SERVICE BULLETIN

Classification: EC20-023A	Reference: NTB20-083A	Date: February 19, 2021
------------------------------	--------------------------	----------------------------

2019-2020 ALTIMA; DTC P2015 OR P2004 STORED DURING COLD WEATHER

APPLIED VEHICLES: 2019-2020 Altima (L34)
APPLIED ENGINE: PR25DD

Figure 1

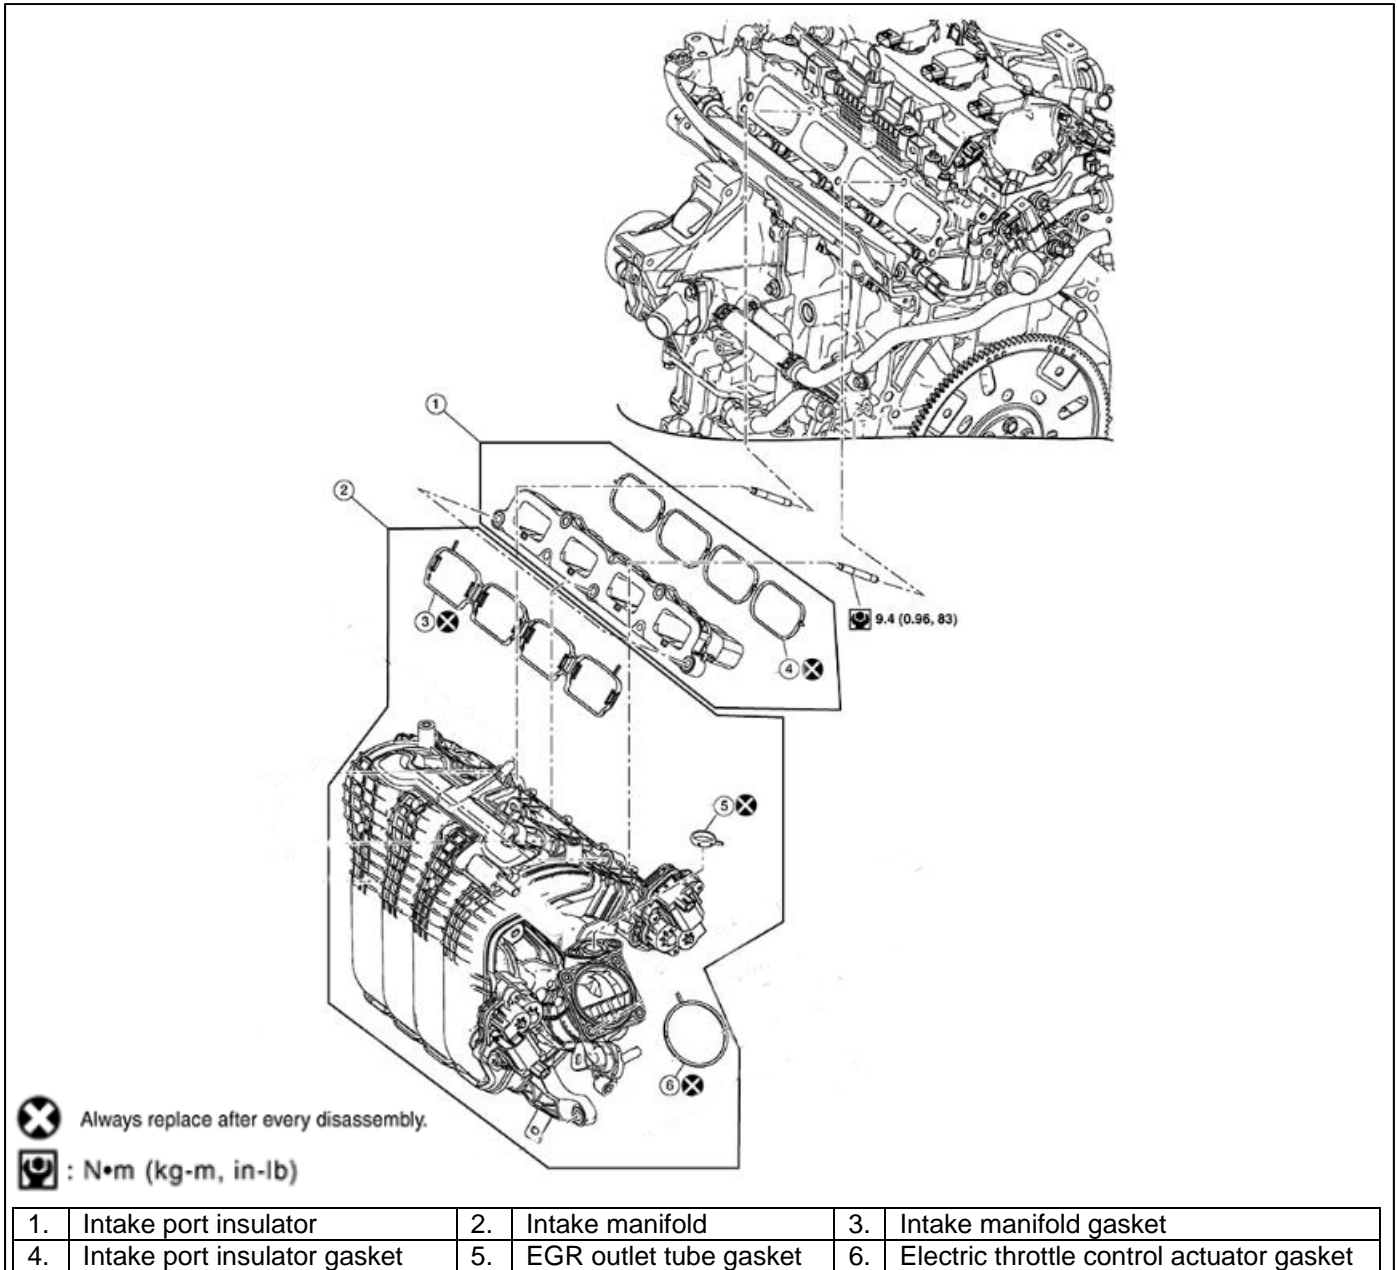
1. Replace the intake manifold.

- For intake manifold replacement, refer to the ESM section: **ENGINE > ENGINE MECHANICAL > PR25DD > REMOVAL AND INSTALLATION > INTAKE MANIFOLD.**
